March 21, 2023

Planning Commission
City of Grosse Pointe Woods
20025 Mack Plaza Dr
Grosse Pointe Woods, MI 48236

Subject: 19850 Mack Avenue Site Plan Review
Parcel ID: 40-012-01-0373-301
Site Plan Review #1
Zoning: C - Commercial Business

Above: location of the proposed freezer installation. Below: an example of a similar installation elsewhere.

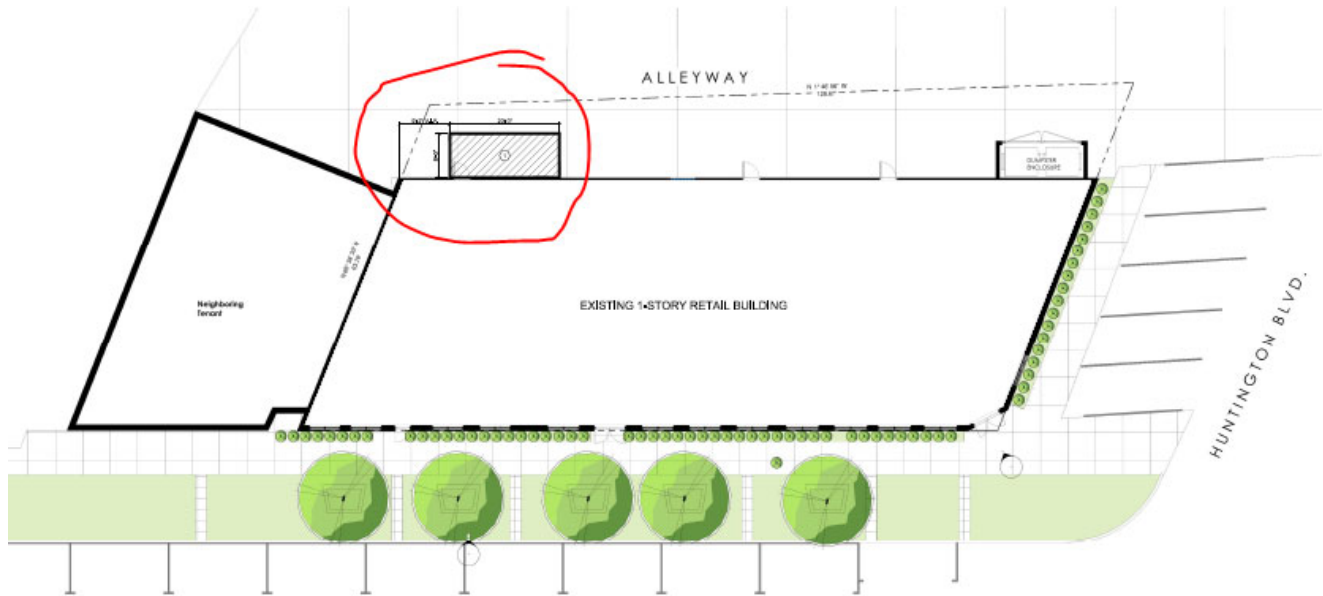
Findings: The subject structure underwent a recent full renovation with new façades approved by the Planning Commission and city. The front façade, clad in brick, limestone and masonry façade with stucco accents, plus metal awnings and parapet panels and caps, is consistent with the ordinance and design standards. The proposed equipment will be installed against a rear façade wall of painted masonry, and if painted to match, or screened to minimize its visual effect, will comply.

Findings: We have not received any lighting plan that may have been submitted and approved along with the elevations, etc. for this structure. If a lighting plan was approved, including for the rear area, this proposed equipment jutting out from the rear wall of the structure may impact the effectiveness of lighting. Specific information about the lighting of this area should be provided to ensure it complies. Can comply.
